## Air Quality Technical Note

Project: London Irish Centre

### London Irish Centre- Air Quality

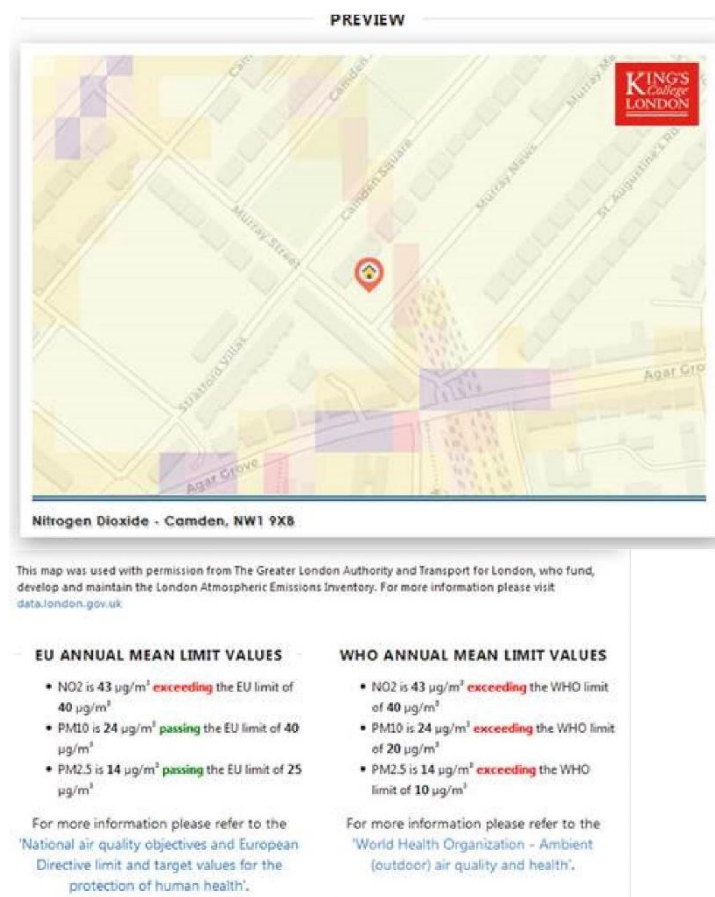
Section 1.3 of the AQA states that " an air quality neutral assessment is no longer required in line with the London Plan as there will be only one residential unit comprised of nine bedrooms and 883 m2 of non-residential construction."

**Issue 1:** The application is for a net increase of 2,815sqm and the development is therefore considered a 'major' development and an AQN assessment is required. **ACTION: Further information required**

It has been confirmed by the project's architect, Coffey Architect, that the non-residential floor space is proposed to increase by 1119m<sup>2</sup> (GIA) and as such the Proposed Development can be classified as Major.

The transport consultant, Caneparo Associates, has confirmed that *"the AADT would stay the same. In particular note that the residential element is an ancillary use and shares its refuse / recycling and servicing arrangements with the London Irish Centre. As the site is car free people staying there would use public transport, walk or cycle"*. Therefore, the Proposed Development is considered air quality neutral with regard to transport emissions and no mitigation is required.

Additionally, the AQA (reference document title REP-1011742-HW-20200228-London Irish Centre Rev01) states: *"The energy provision for the Proposed Development will be met by Air Source Heat Pumps (ASHPs) for the hot water system and photovoltaic panels which do not release any emissions. Natural gas will only be used for the kitchen appliances. As the only gas use is for the kitchen appliances, the proposed emission rate for this plant is expected to be below the criteria set out in the EPUK/IAQM guidance. As such the impact from combustion plant will be negligible and no mitigation is required."*

As such, the Proposed Development is also considered air quality neutral with regard to building emissions, and no mitigation is required.
